Product Change Notice (PCN)

PCN Number: PCN-0460231R-01**To Our Customers:**

Product(s) Affected: TB009-508 series

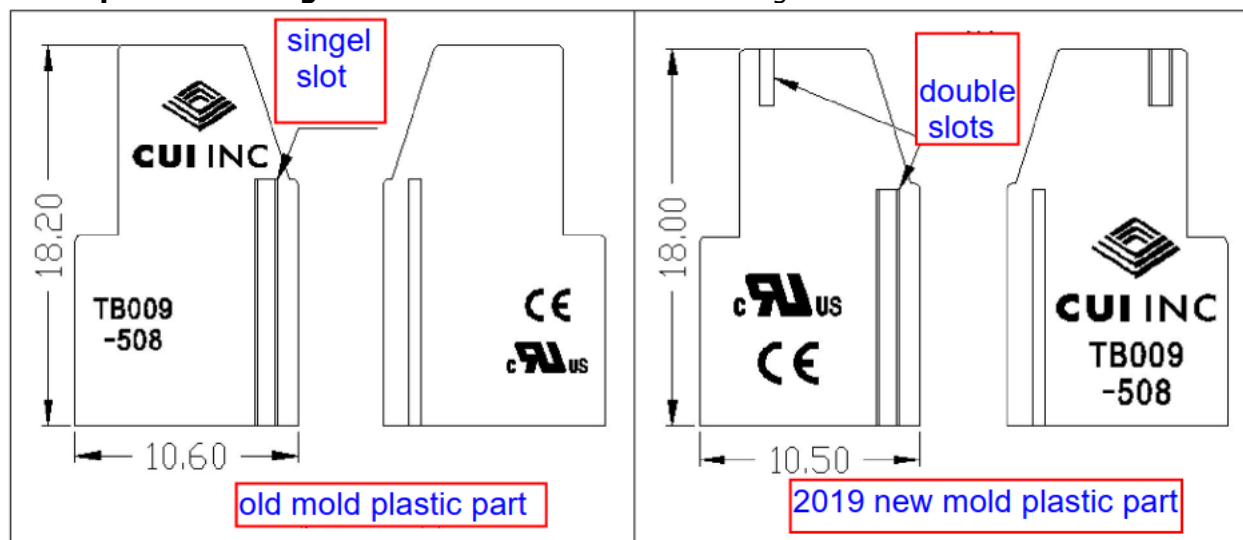
Reason(s) for Change: To promote the efficiency of automated assembly machine.

Description of Change: Additional slot for ease of configuration as shown below:

Additional Information: Products using the old mold cannot be connected to products using the new mold.
